Application for Third Amendment to
Siting Certificate for Hog Creek Wind Farm LLC
Hardin County, Ohio

Hog Creek I Wind Farm

Case No. 16-1422-EL-BGA

Ohio Power Siting Board
Columbus, Ohio
June 22, 2016

Figure 02-1 Project Schedule

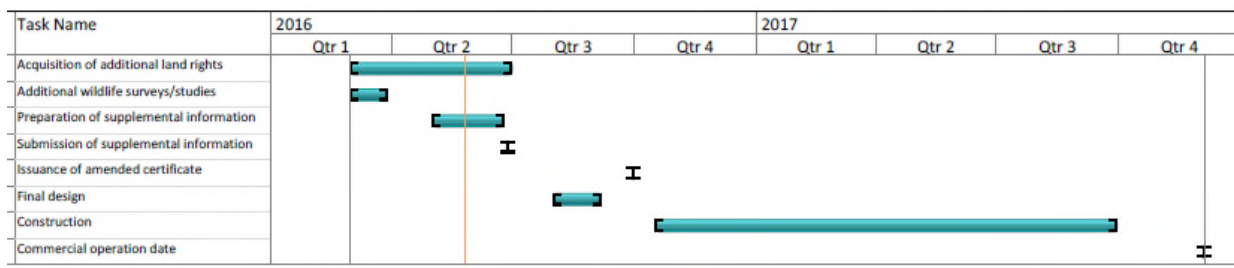
A new Combined Project schedule is provided as Figure 02-1.
